SUBJECT: ISSUANCE OF AMENDMENT NO. 12 TO FACILITY OPERATING LICENSE
NO. NPF-63 - SHEARON HARRIS NUCLEAR POWER PLANT, UNIT 1,
REGARDING INCREASING MAXIMUM ALLOWED ENRICHMENT OF STORED
FUEL (TAC NO. 72885)

SHEARON HARRIS NUCLEAR POWER PLANT, UNIT 1

SAFETY EVALUATION BY THE OFFICE OF NUCLEAR REACTOR REGULATION
SUPPORTING AMENDMENT NO. 12 TO FACILITY OPERATING LICENSE NO. NPF-63

Figure 2. Shearon Harris Fuel Assembly Minimum Number of IFBA Rods vs. Initial U^{235} Enrichment for Storage in Region 1 Spent Fuel Racks
"Criticality Analysis of Shearon Harris Spent Fuel Racks with IFBA Fuel," Westinghouse, November, 1988.

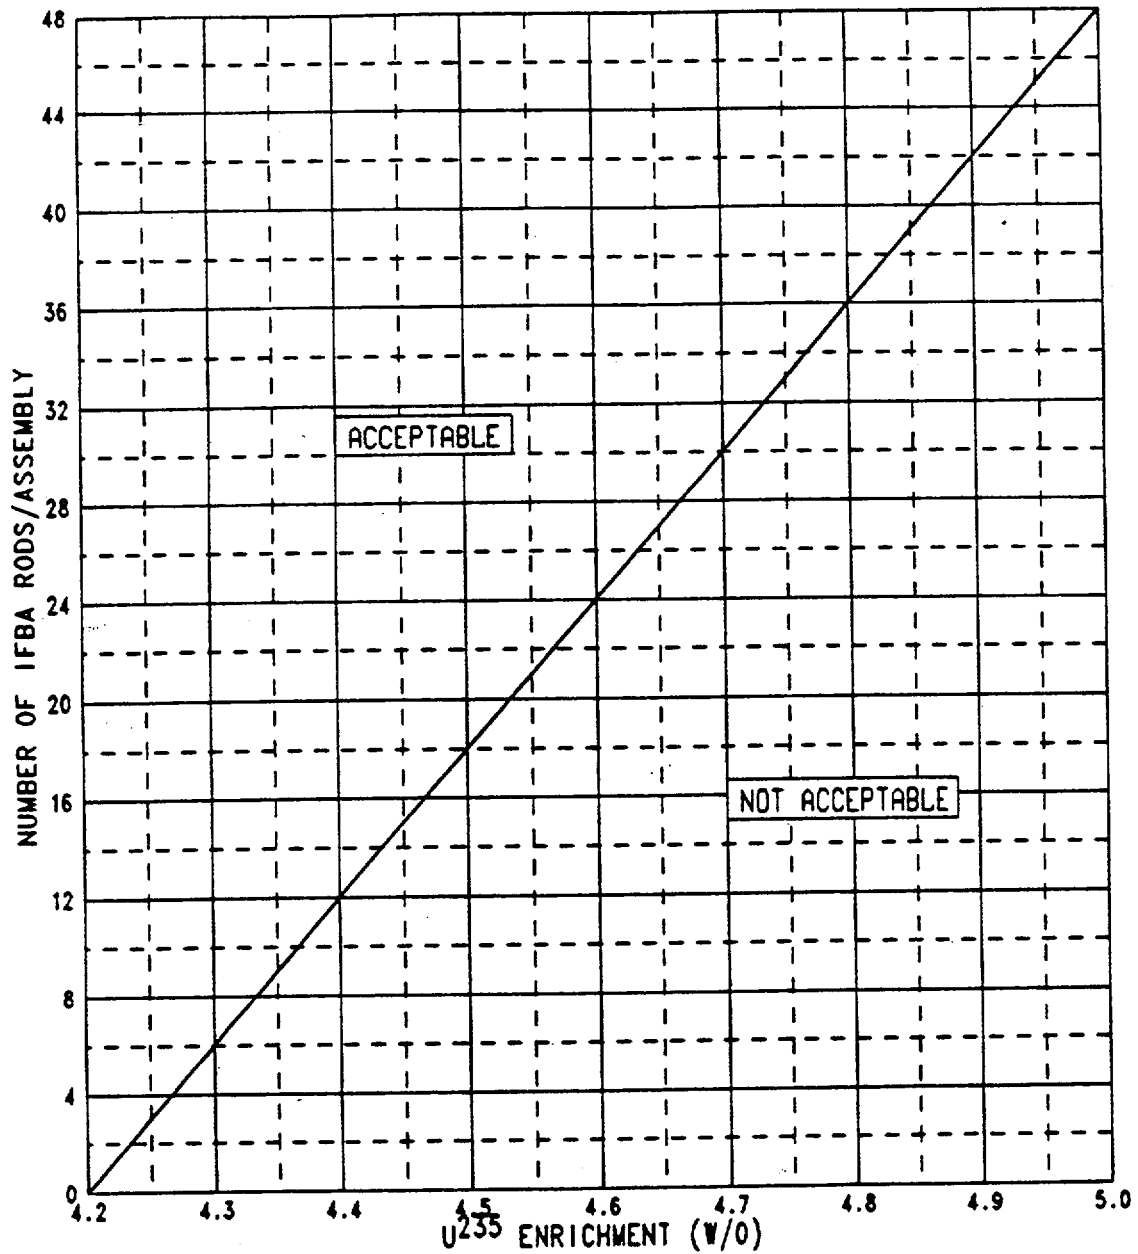
The concept of reactivity equivalencing is predicated upon the reactivity decrease associated with the addition of IFBA fuel rods and fuel depletion. A series of reactivity calculations are performed to generate a set of IFBA rod numbers versus enrichment-ordered pairs which all yield the equivalent k -effective when the fuel is stored in the spent fuel racks. This is shown in the enclosed Figure which appeared in the supporting Westinghouse report noted above. From the Figure, it can be seen that the rack reactivity of fuel with 48 IFBA rods with an initial U-235 enrichment of 5.0 weight percent is equivalent to the rack reactivity of unirradiated fuel having an initial U-235 enrichment of 4.2 weight percent. The method of reactivity equivalencing has been widely used by other licensees for fuel storage analyses and has been accepted by the staff.

In order to store fuel assemblies that may have a non-standard IFBA rod pattern and, therefore, cannot use the IFBA versus enrichment Figure, an infinite multiplication factor for a nominal fresh 4.2 weight percent U-235 fuel assembly was determined. As mentioned earlier, this is equivalent to the reactivity of a 5.0 weight percent U-235 fuel assembly with 48 IFBA rods. When k -infinity is used as a reference reactivity point, the need to specify an acceptable enrichment versus number of IFBA rods correlation is eliminated. Calculation of the infinite multiplication factor for a fuel array of 4.2 weight percent fuel in

the Harris reactor geometry resulted in a reference k-infinity of 1.470. The licensee has shown that fuel with a reference k-infinity of 1.470 results in a maximum k-effective of less than 0.95 when stored in the Shearon Harris spent fuel storage racks. Therefore, the only requirement needed to ensure that the fuel racks are maintained at a k-effective below 0.95 is to verify that for each assembly, the k-infinity is no greater than 1.470 at 68°F in the core geometry. The IFBA rods versus enrichment Figure is, of course, an acceptable way for the licensee to verify that the k-infinity limit is met if a particular fuel assembly design meets the assumptions under which the enclosed Figure was generated.

Based on the above evaluation, the staff concludes that the spent fuel storage racks at Harris can accommodate Westinghouse 17x17 standard or optimized fuel assemblies with maximum enrichments of 5.0 weight percent U-235 provided that fuel with enrichments greater than 4.2 weight percent U-235 contain sufficient integral burnable absorbers such that the maximum core geometry k-infinity of these assemblies is no greater than 1.470 at 68°F.
